10BASE-T1L PHY Control synchronization (802.3cg D2.0)

NIALL FITZGERALD

15 AUGUST 2018

10BASE-T1L PHY Control restart

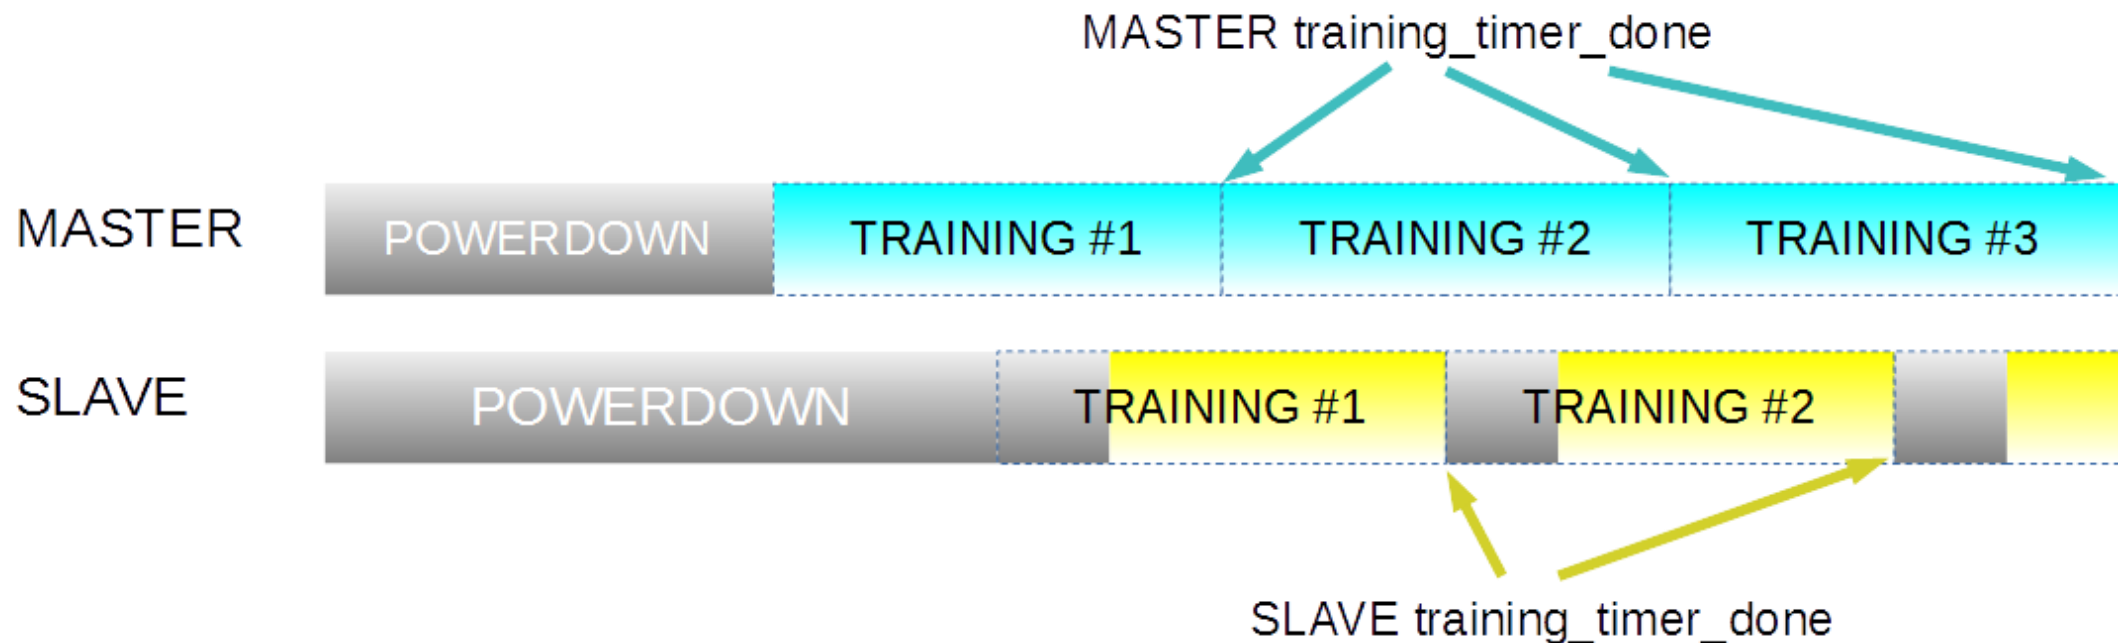
If training_timer_done occurs, PHY Control state diagram transitions back to DISABLE TRANSMITTER state

- Full restart of link startup/training
- PHY should clear previous state (of channel equalizer, echo canceller, timing recovery functions)

Both PHYs need to have completed training before training_timer expires

- Both loc_rcvr_status and rem_rcvr_status required for transition to SEND IDLE

There is no mechanism to synchronize operation of PHY Control in MASTER and SLAVE PHYs in FORCE mode.

- They will start (i.e. exit DISABLE TRANSMITTER) at different times
- training_timer will not be synchronized.
- PHY might not have enough time to allow completion of training (in both PHYs)
- Situation might persist
